| Case No. | ARB1810-01 | Phone: | 512-990-6304 |

SUBJECT: Discuss and consider an application for an Architectural Waiver for the properties located at 2141 and 2126 Rowe Loop, to allow for a reduction in the amount of primary masonry and allow for an increase in the secondary masonry allowed for a single family attached product. (ARB1805-01)

STAFF REPORT

Project: **Rowe Loop Condos (formerly Huntington Park)**
2141 and 2126 Rowe Loop
Pflugerville, Texas 78660

PROPOSED PRODUCT AS VIEWED FROM ROWE LANE:

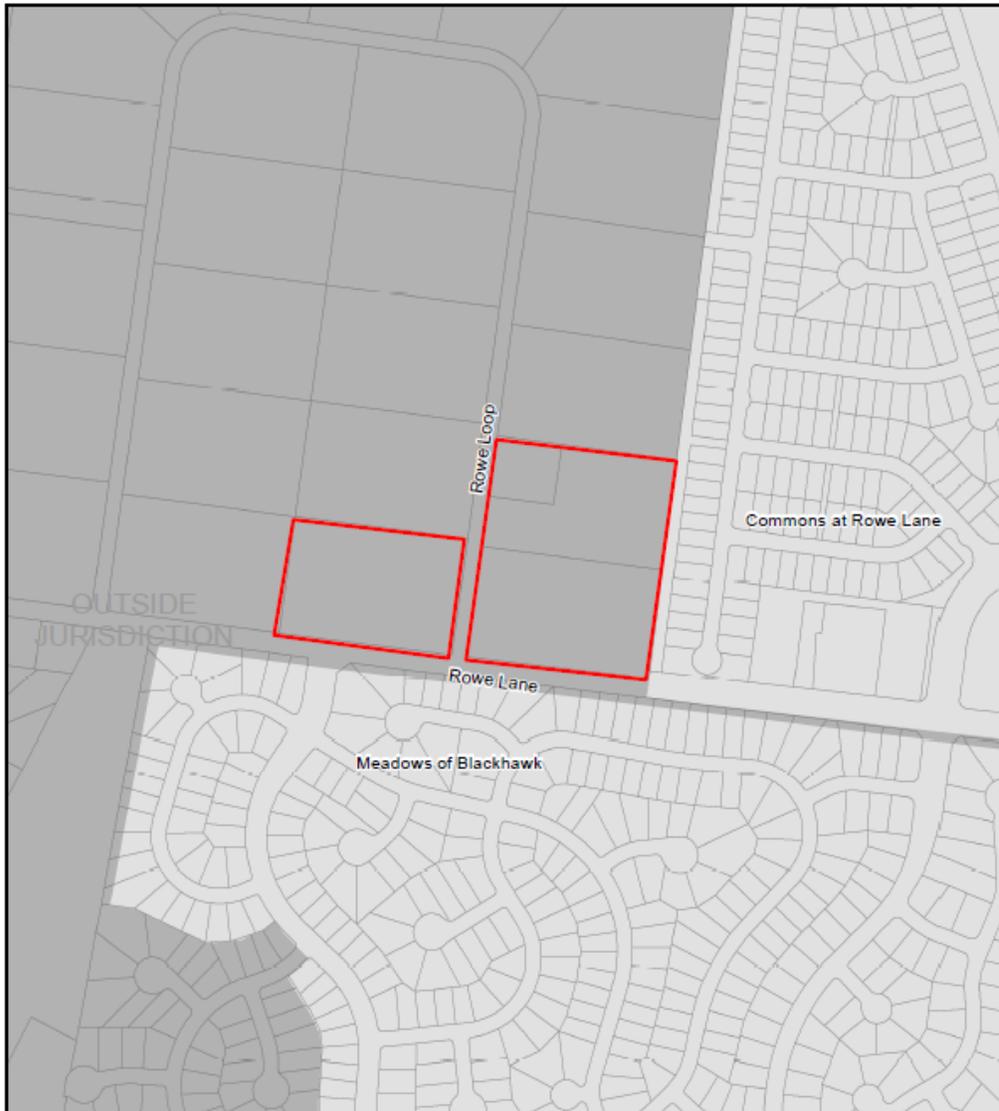
The intent of the material percentages provided in the SF-MU district is to ensure the quality of the residential products built in the district were not diminished with the implementation of small lots, or condominium developments. While the proposed designs deviate significantly from the minimum masonry requirements, the proposed waiver will allow the visual elements needed to establish the traditional architectural designs of farmhouse, craftsman, and mid-century modern. The proposed styles are currently trending in other jurisdictions and are not achievable by our current design standards for any district without pursuing a PUD or similar agreement.

By allowing the waiver, the intent of delivering an aesthetically pleasing product within the proposed neighborhood will be retained. If the waiver is approved, Staff recommends limiting the approval to the elevations provided with this application (included as separate attachments to this staff report), subject to compliance with all other architectural detail requirements established in Subchapter 9 of the Unified Development Code. In addition, the proposed floor plans shall alternate throughout the neighborhood to prevent monotony and comply with the elevation differentiation currently outlined in the UDC.
